### LAYOUTS AMENDMENTS

**EAST END ROAD**

**S73 DESIGN DOCUMENT** FEBRUARY 2024

**NORTH ELEVATION - PROPOSED**

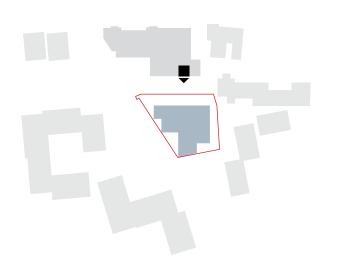
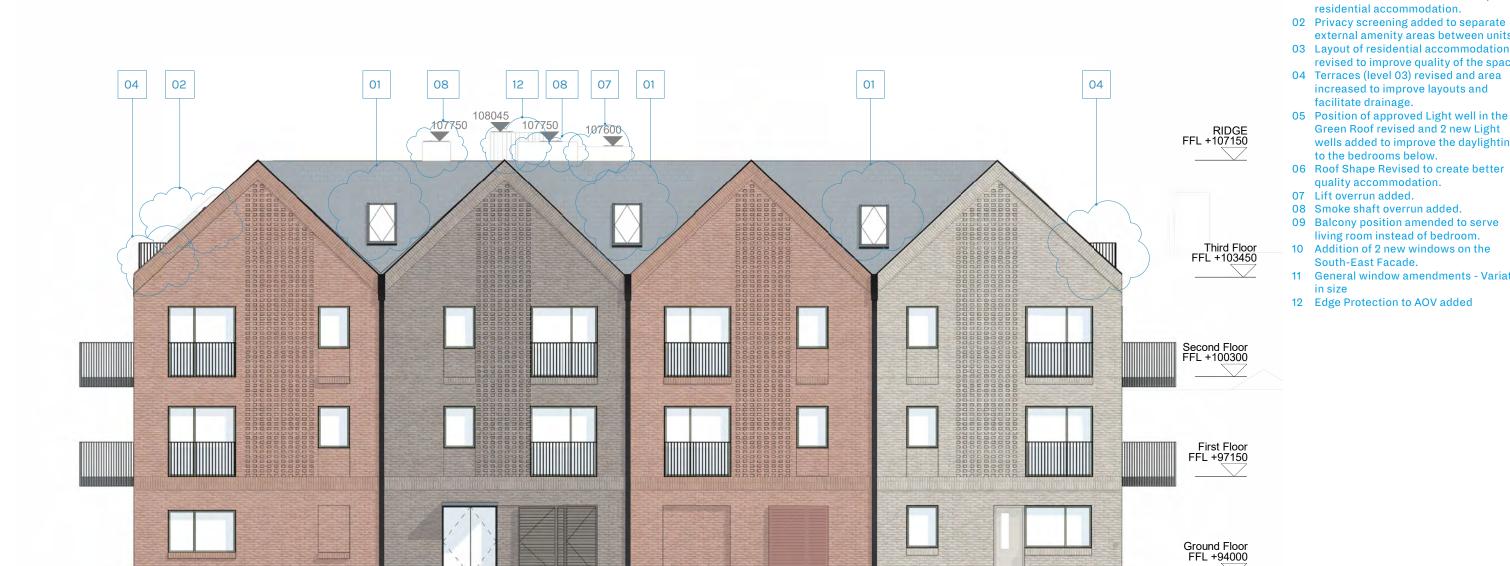
- 01 Roof-lights added within the pitched roof at Level 03 to create better quality residential accommodation.
- external amenity areas between units.
- 03 Layout of residential accommodation revised to improve quality of the space.
- 04 Terraces (level 03) revised and area increased to improve layouts and facilitate drainage.
- 05 Position of approved Light well in the Green Roof revised and 2 new Light wells added to improve the daylighting to the bedrooms below.
- 06 Roof Shape Revised to create better quality accommodation.
- 08 Smoke shaft overrun added.
- 09 Balcony position amended to serve living room instead of bedroom.
- 10 Addition of 2 new windows on the South-East Facade.
- 11 General window amendments Variation
- 12 Edge Protection to AOV added

**SOUTH ELEVATION - PROPOSED**

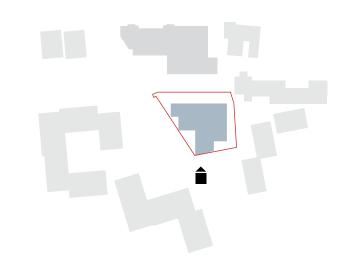
- 01 Roof-lights added within the pitched roof at Level 03 to create better quality residential accommodation.
- external amenity areas between units.
- 03 Layout of residential accommodation revised to improve quality of the space.
- 04 Terraces (level 03) revised and area increased to improve layouts and facilitate drainage.
- 05 Position of approved Light well in the Green Roof revised and 2 new Light wells added to improve the daylighting to the bedrooms below.
- 06 Roof Shape Revised to create better quality accommodation.
- 07 Lift overrun added.
- 08 Smoke shaft overrun added.
- 09 Balcony position amended to serve living room instead of bedroom.
- 10 Addition of 2 new windows on the South-East Facade.
- 11 General window amendments Variation
- 12 Edge Protection to AOV added

**WEST ELEVATION - PROPOSED**

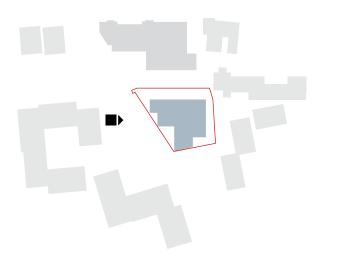
- 01 Roof-lights added within the pitched roof at Level 03 to create better quality residential accommodation. 02 Privacy screening added to separate
- external amenity areas between units.
- 03 Layout of residential accommodation revised to improve quality of the space.
- 04 Terraces (level 03) revised and area increased to improve layouts and facilitate drainage.
- 05 Position of approved Light well in the Green Roof revised and 2 new Light wells added to improve the daylighting to the bedrooms below.
- 06 Roof Shape Revised to create better quality accommodation. 07 Lift overrun added.
- 08 Smoke shaft overrun added.

- 09 Balcony position amended to serve living room instead of bedroom.
- 10 Addition of 2 new windows on the South-East Facade.
- 11 General window amendments Variation
- 12 Edge Protection to AOV added

**EAST ELEVATION - PROPOSED**

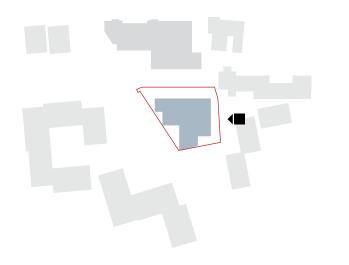
O1 Roof-lights added within the pitched roof at Level 03 to create better quality residential accommodation.

02 Privacy screening added to separate

- external amenity areas between units.
- 03 Layout of residential accommodation revised to improve quality of the space.
- 04 Terraces (level 03) revised and area increased to improve layouts and
- facilitate drainage.

O5 Position of approved Light well in the
  Green Roof revised and 2 new Light
  wells added to improve the daylighting
- to the bedrooms below.

O6 Roof Shape Revised to create better quality accommodation.
- 07 Lift overrun added.
- 08 Smoke shaft overrun added.
- 09 Balcony position amended to serve living room instead of bedroom.
  10 Addition of 2 new windows on the
- South-East Facade.
  11 General window amendments Variation
- in size
- 12 Edge Protection to AOV added
